IEEE 802.3ae Meeting, New Orleans, Sept. 12-14, 2000

Comments on Serial PMD Optical Specs.

Marc Verdiell, LightLogic Inc. mverdiell@lightlogic.com

1.3um DFB with Back Reflection

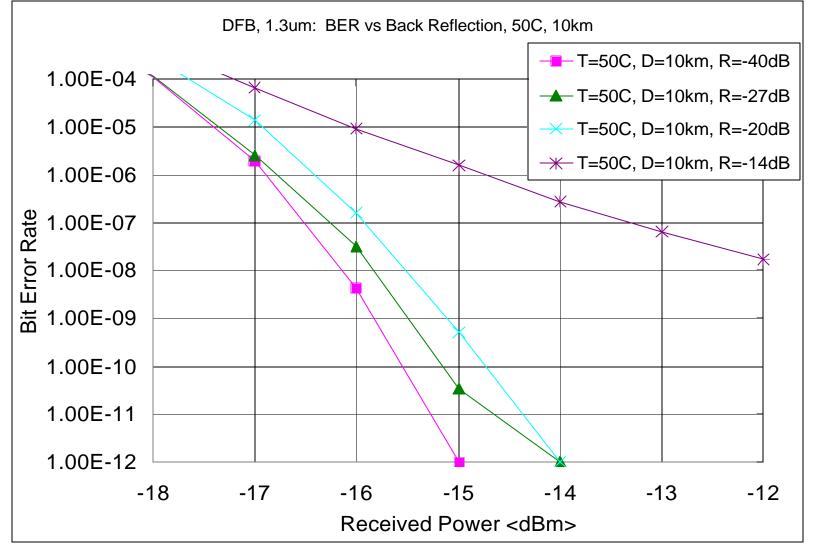
- Common Conditions: T=50C, Extinction Ratio=6 dB, Distance=10 km
- Varying return loss from -40 to -14 dB
- This un-isolated DFB cannot work under -14 dB return

FP, 1.3um: Eye Diagrams vs. Back Reflection

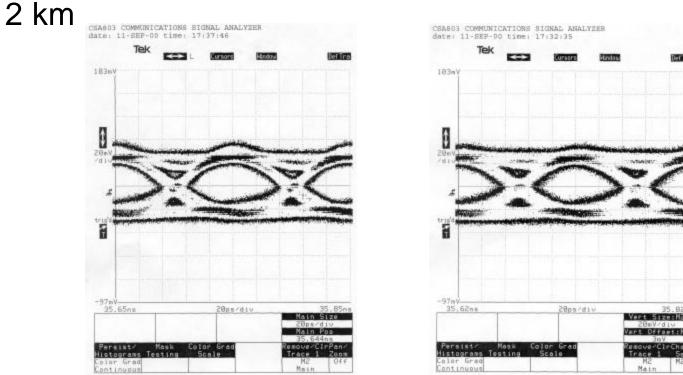
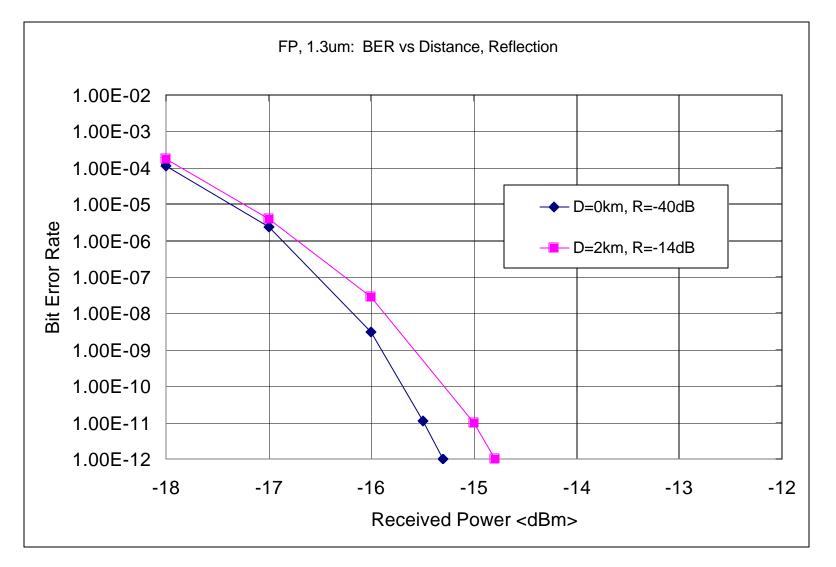
- Common Conditions: T=25C, Extinction Ratio=6 dB
- This un-isolated FP can work under -14 dB return loss at

OC-48 Sonet vs Proposed 10GbE

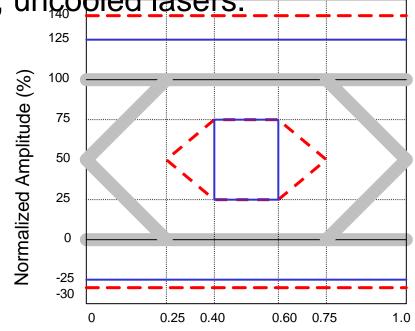
- Start with scaled OC-48 SONET mask (solid square)
- Added "corners" internal to eye, corresponding to previous 1GbE spec.
- Enlarged over and under shoot areas to allow for direct modulated, uncooled lasers.

Eye Mask Example 1 - Uncooled FP

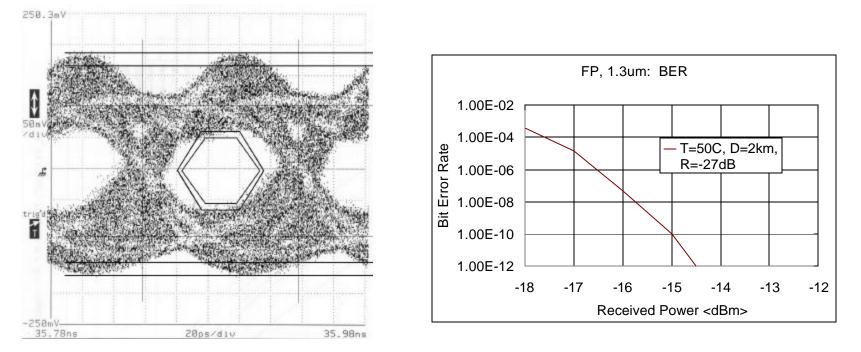
- Outside mask is currently proposed 10 GbE
- Inside mask is our proposed 10GbE (modified SONET)
- Fails both even though it passes BER

Eye Mask Example 2 - Uncooled DFB

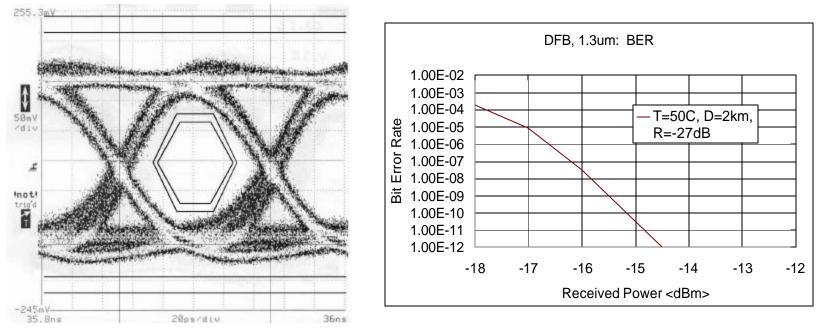
- Fails original proposed 10GbE mask.
- Passes our proposed mask.
- BER performance < 10^-12 @ -14 dBm

Eye Mask Example 3 - Cooled Isolated DFB

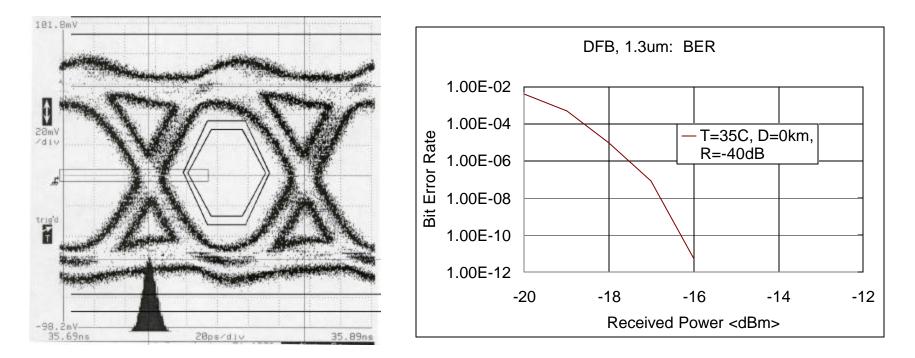
- Passes both proposed 10GbE mask and our proposed mask.
- BER < 10^-12 @ 16 dBm
